Ramsey Town Center  
Alternative Urban Areawide Review  
June 24, 2003

Prepared for the City of Ramsey  
by Ramsey Town Center - LLC,  
Emmons and Olivier Resources, Inc.  
North American Wetland Engineering, and  
Meyer, Mohaddes Associates, Inc.

***Alternative Urban Areawide Review (AUAR)***  
***Ramsey Town Center***  
***City of Ramsey (RGU)***

COMPARISON AUAR Graphical Fig 8-Future w/ Project PM IDR

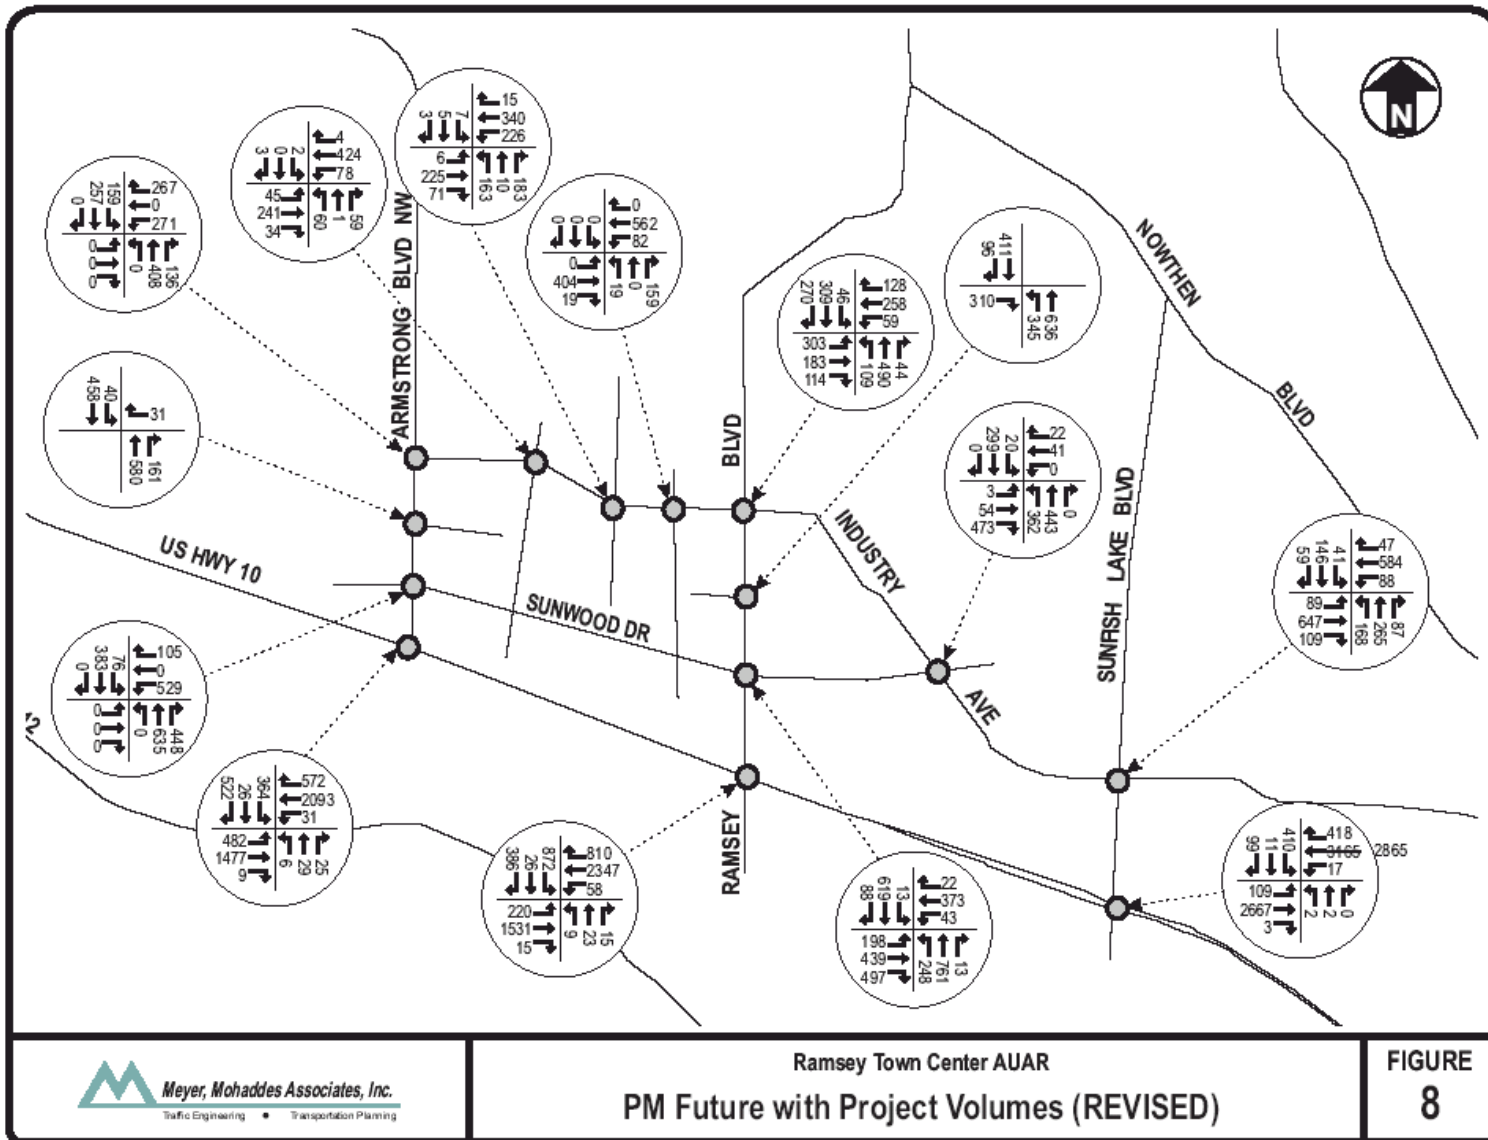
**Comment 6.6:** In Appendix B, please re-check the traffic assignments in Figures 7 and 8. For example, in Figure 8 (PM), the difference in the through volumes (for with, and without project) on westbound TH 10 at Sunfish Lake Blvd. NW is 1,065 (3,165 - 2,100). This number also represents the traffic entering the development in the afternoon (PM) from the east on TH 10 (43 percent of 2,480). If the differences in the Left Turns, and Right Turns at Ramsey Blvd. and Armstrong Blvd. NW are added, the result is 779. It appears that there is no accounting for 286 vehicles. These figures must be double-checked for accuracy, and any revised traffic information submitted to Mn/DOT (contact given).

**Response:** The turning movement assignments in Figures 7 and 8 of Appendix B have been rechecked. The westbound through movement at Sunfish Lake in the PM peak has been adjusted from 3,165 vehicles to 2,865 as shown in Revised Figure 8 ([Attachment 1 at the end of this response document](#)) to account for 300 inbound (to the project) vehicles that are assigned to use Sunfish Lake Boulevard to reach Industry Avenue. Of the 300 vehicles in this revision, 100 were assumed to use Sunfish Lake Boulevard and are included in the 418 vehicles assigned to the westbound right turn at Sunfish Lake Boulevard. The other 200 vehicles are assigned to the westbound through movement on Industry Avenue at Sunfish Lake Boulevard.

The turning movements in original Figure 8 on Sunfish Lake Boulevard and Industry Avenue included these vehicles and are not revised. Revised Figure 8, when compared to original Figure 5 (the future base traffic assignment), shows that 765 vehicles would enter the project from TH 10 east of Sunfish Lake Boulevard. The incremental difference in traffic turning right onto Ramsey and Armstrong Boulevards is 772. The difference between the two numbers is the result of rounding up during calculations made by the Traffix (computer modeling) program as it makes the incremental assignments from the multiple zones within the project site. Four additional pages of Appendix B are revised to account for this adjustment in traffic volumes: future with project (no mitigation)
